## ADDENDUM

**ADDENDUM NO.:** 01  
**PROJECT NAME:** CIP Central Hearing Facility Roof and MEP Upgrades  
**PROJECT NO.:** 04044  
**CONTRACT NO.:** C1606  
**DATE OF ISSUE:** December 21, 2023

### NOTICE OF CHANGES, MODIFICATIONS, OR CLARIFICATIONS TO CONTRACT DOCUMENTS

**1 THIRD FLOOR REFLECTED CEILING NEW WORK PLAN**  
SCALE: 1/8"=1'-0"

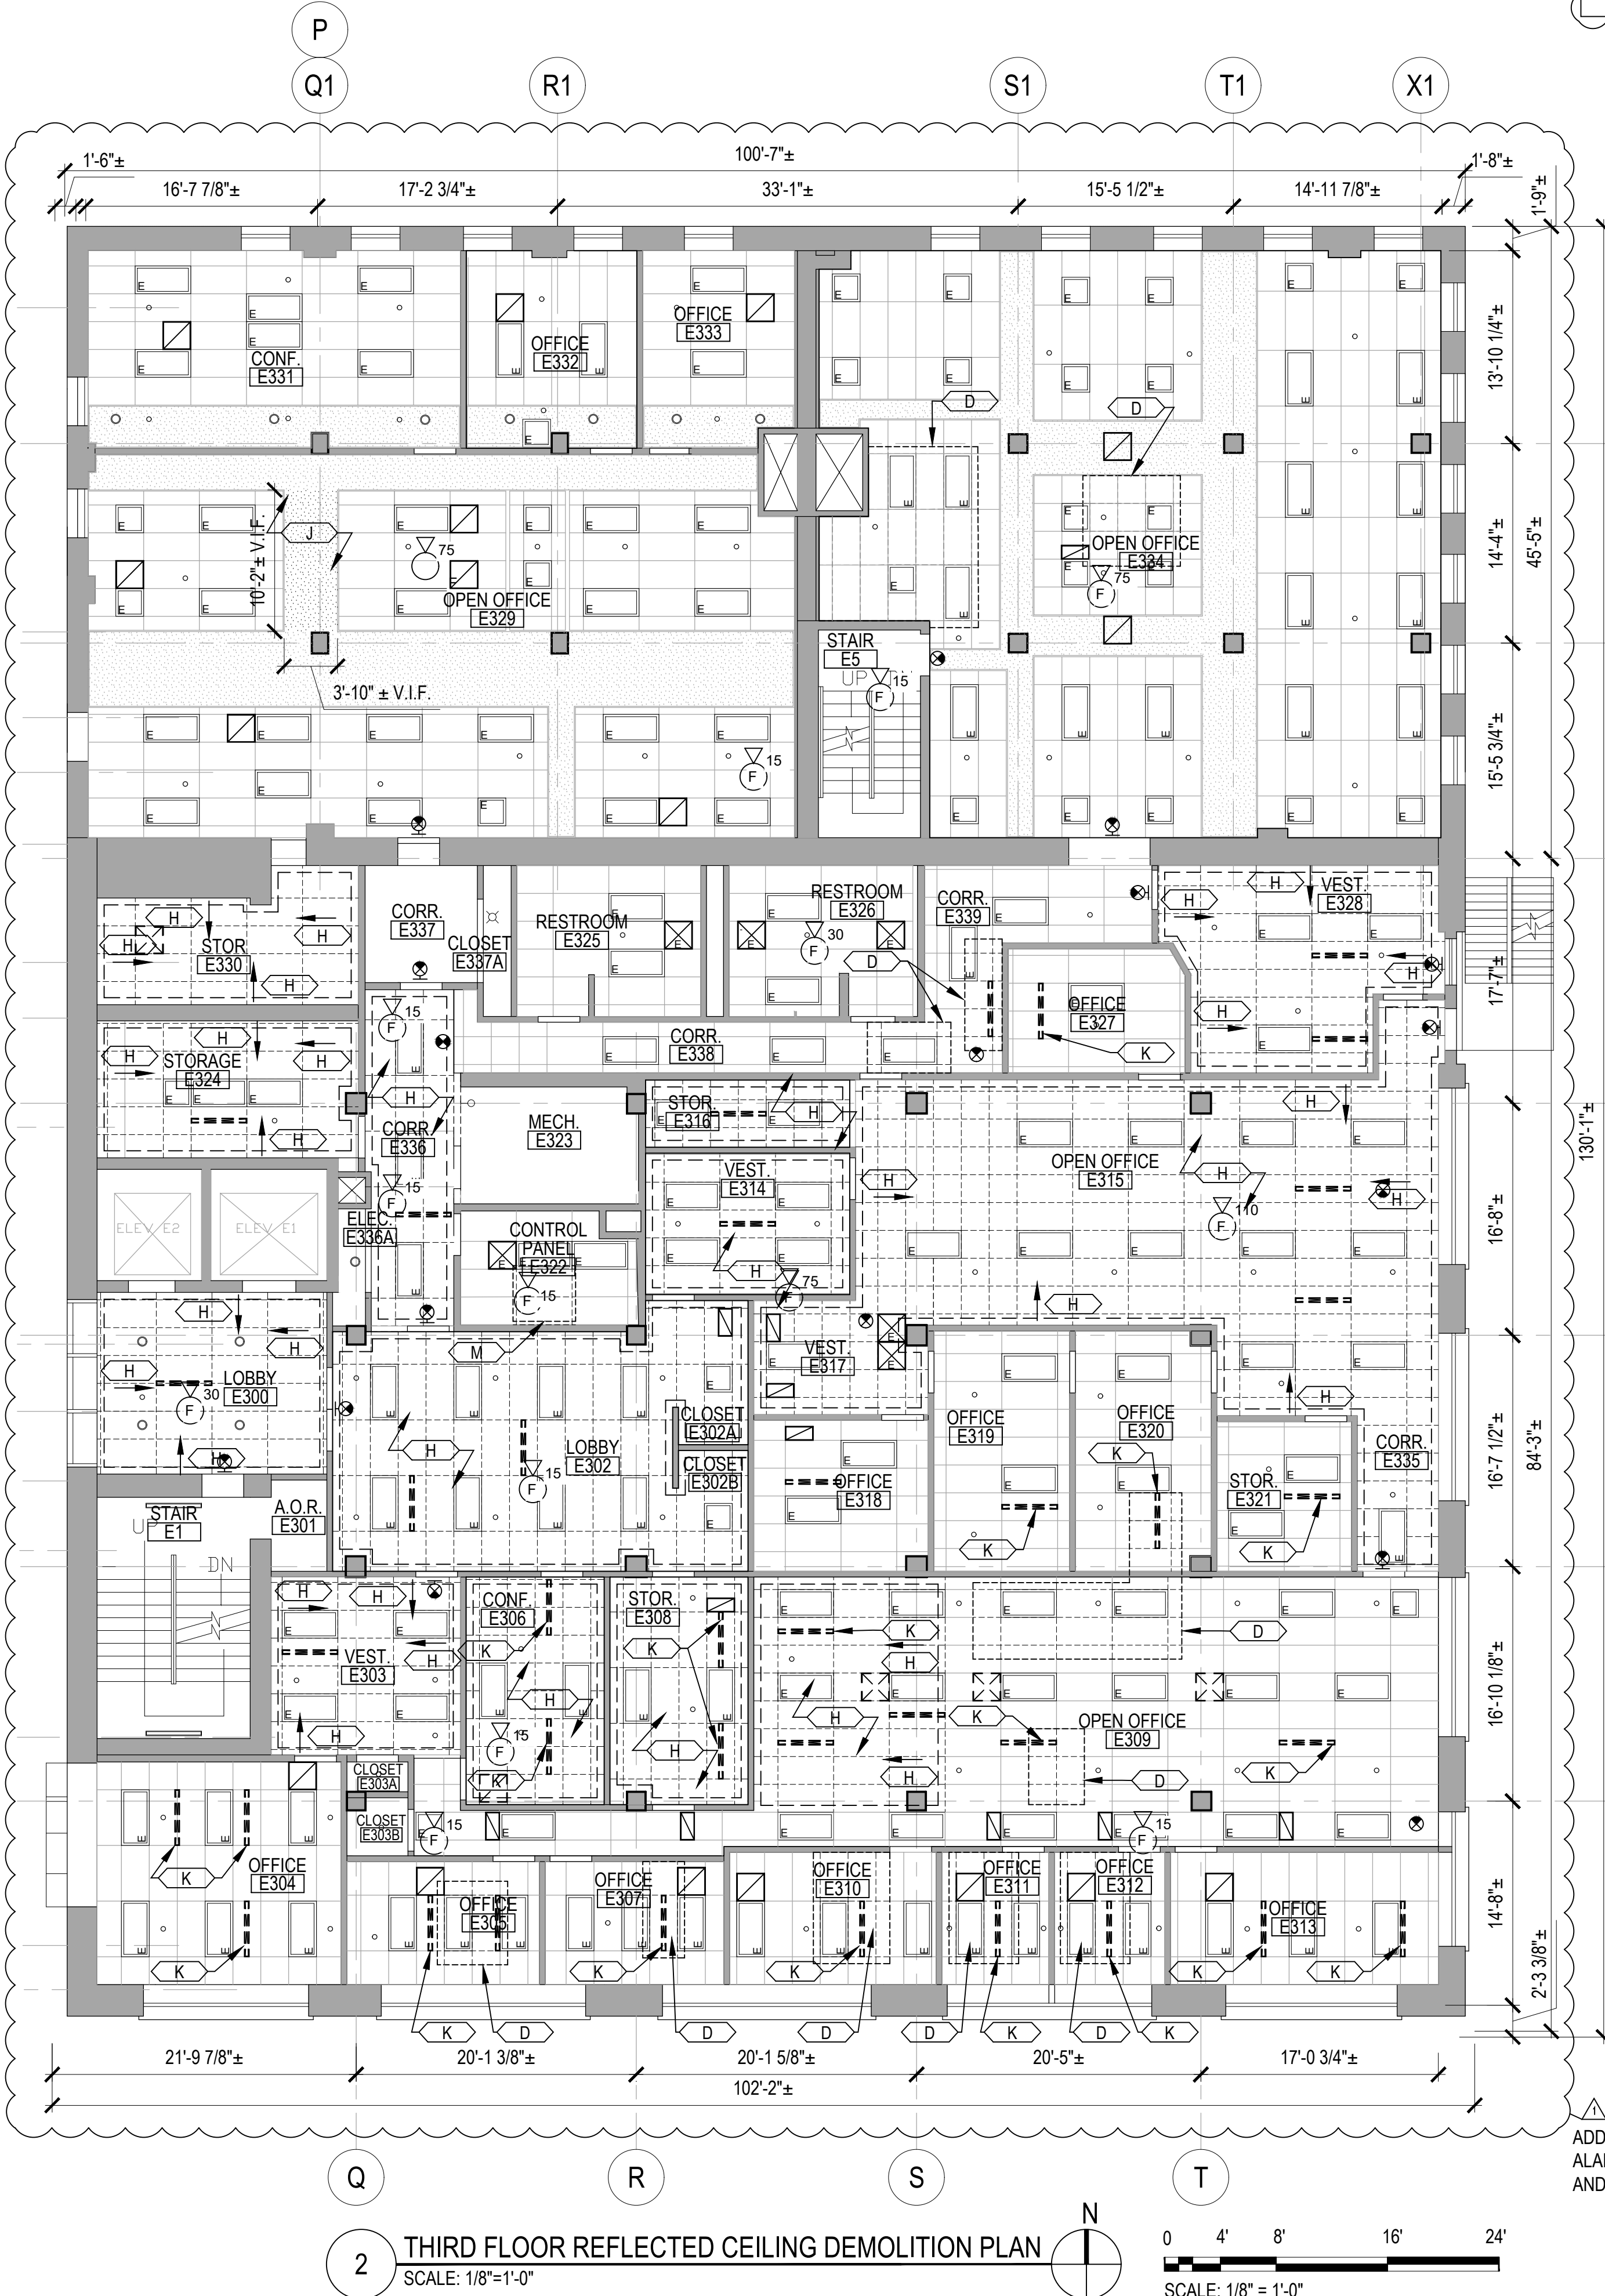
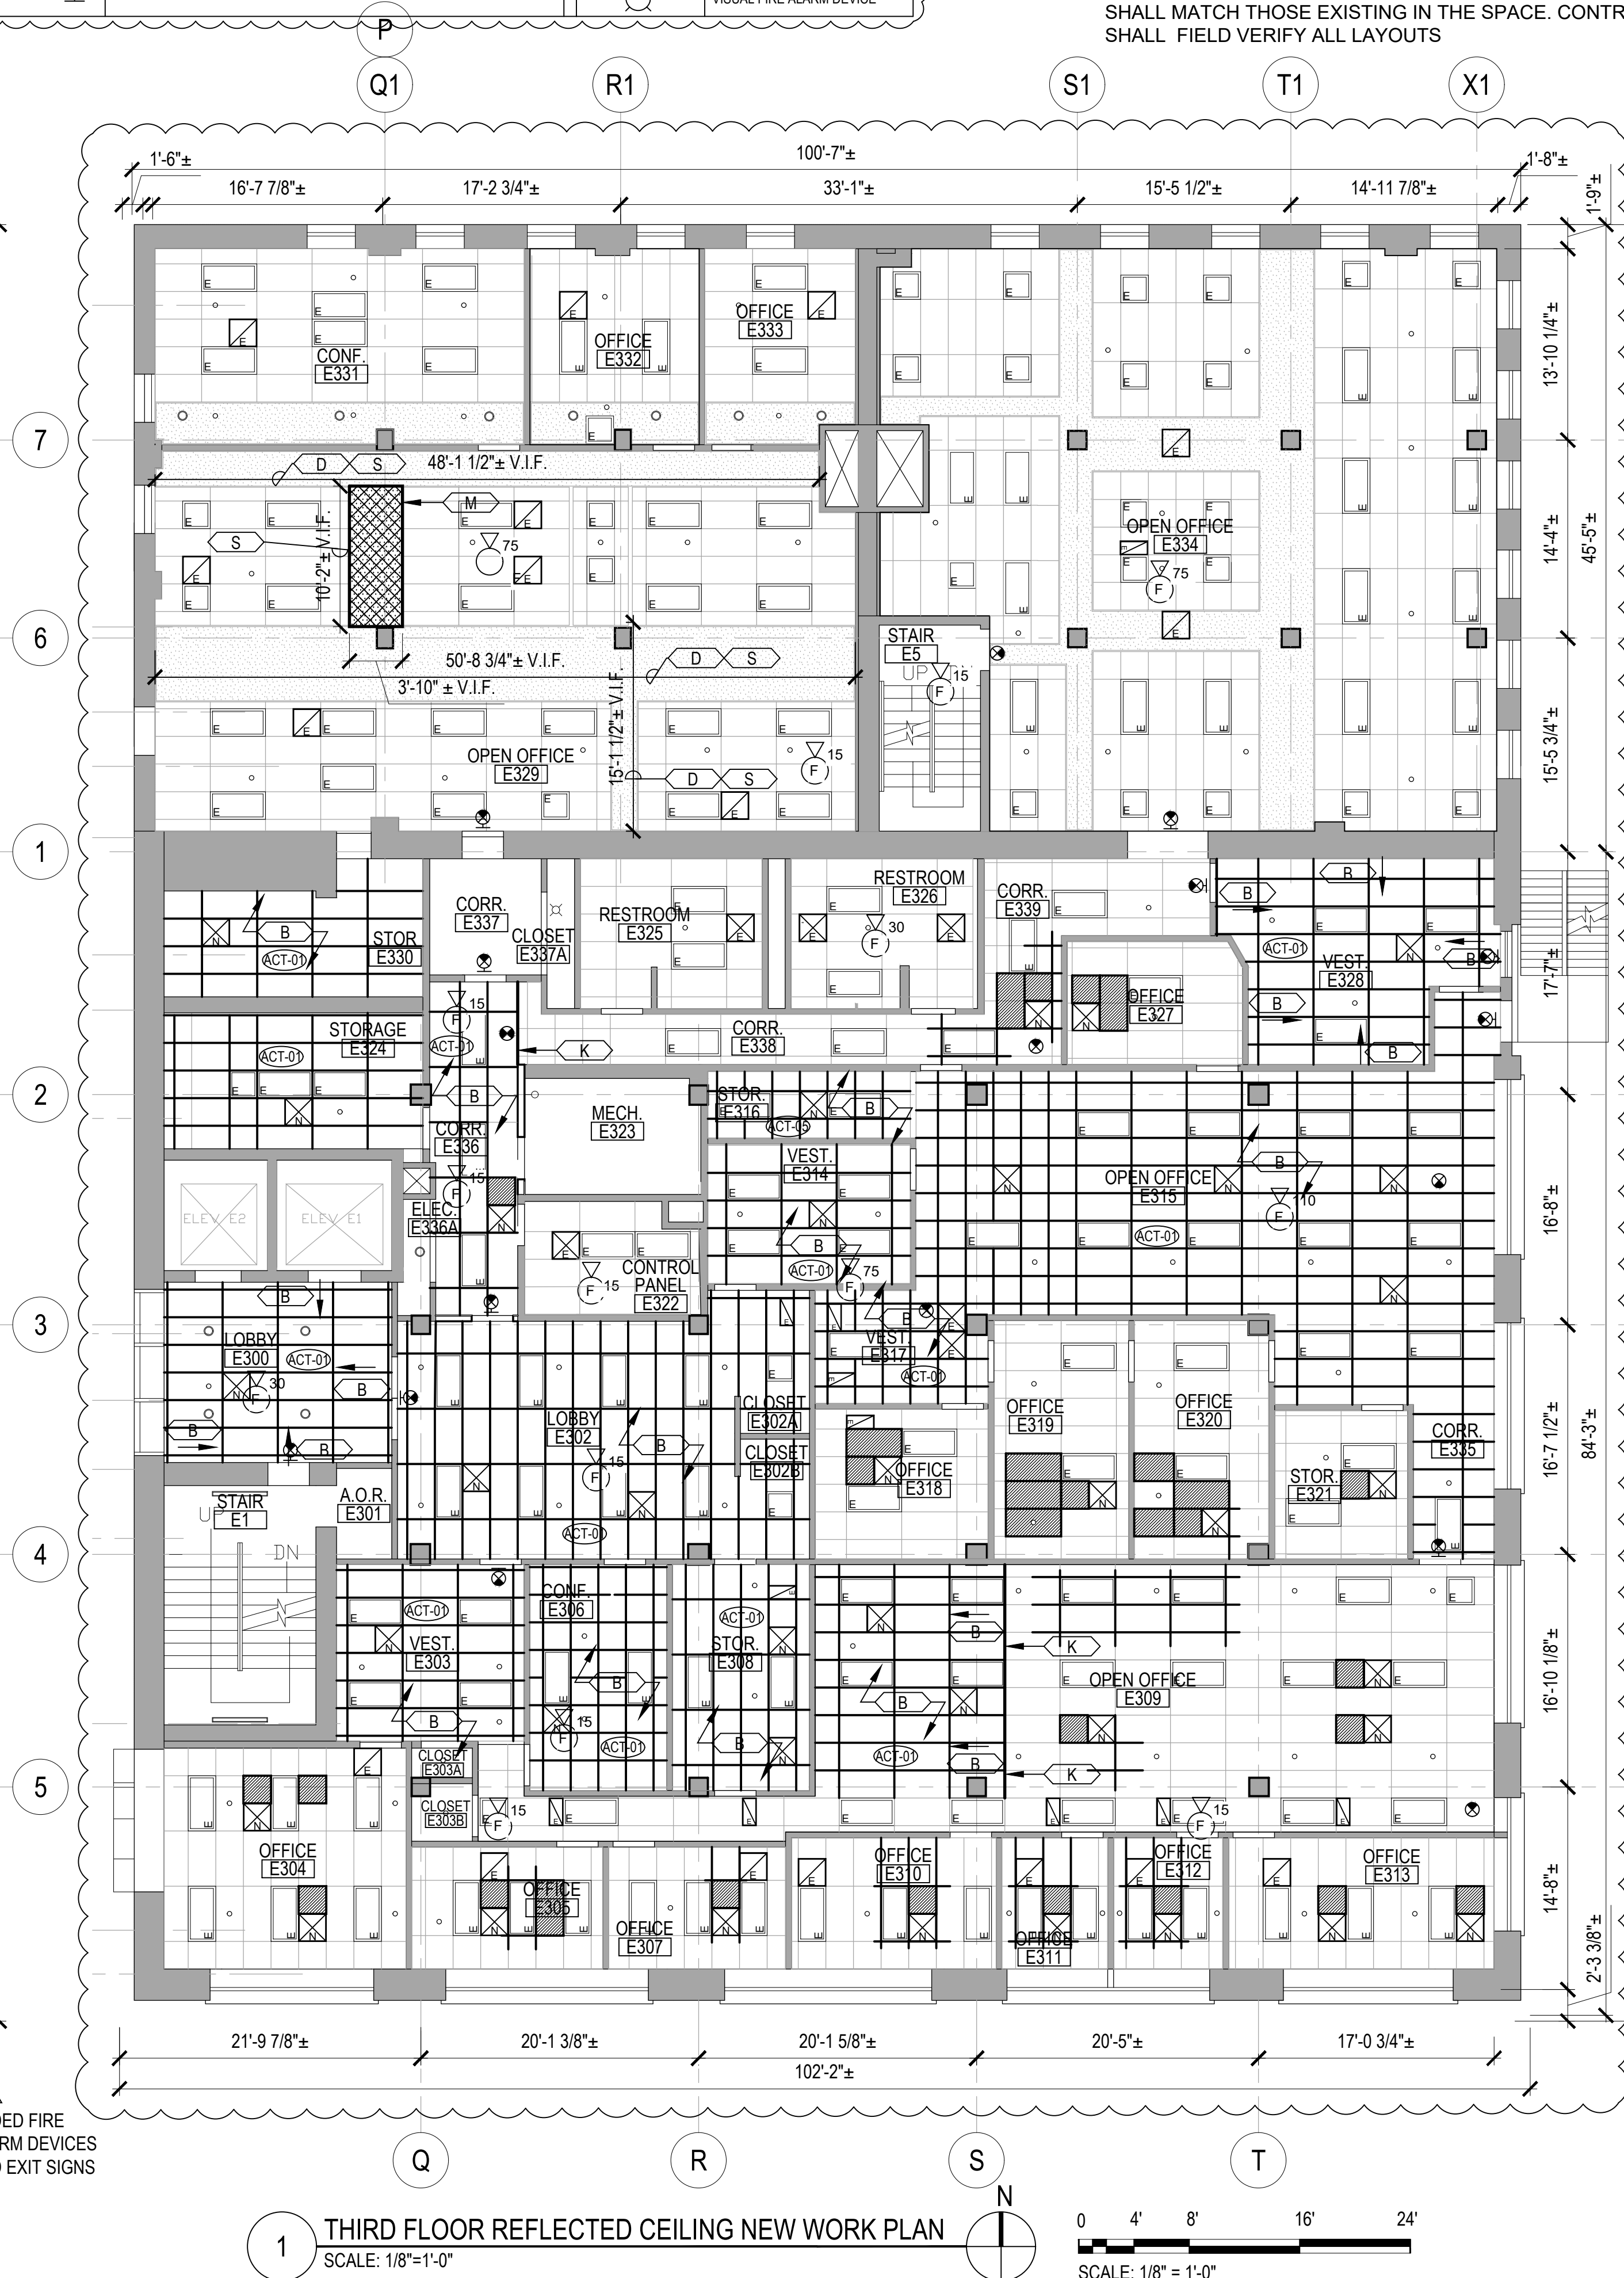
**Change 11** Drawing No. AC-103 –**REVISED** sheet to add existing ceiling hung devices. dated 12.21.23  
**Change 12** Drawing No. AC-104 –**REVISED** sheet to add existing ceiling hung devices, dated 12.21.23

**Response:** [Ceiling plans have been revised to identify the ceiling-mounted exit signs and fire alarm devices. Please refer to architectural drawings included in this addendum.](#)
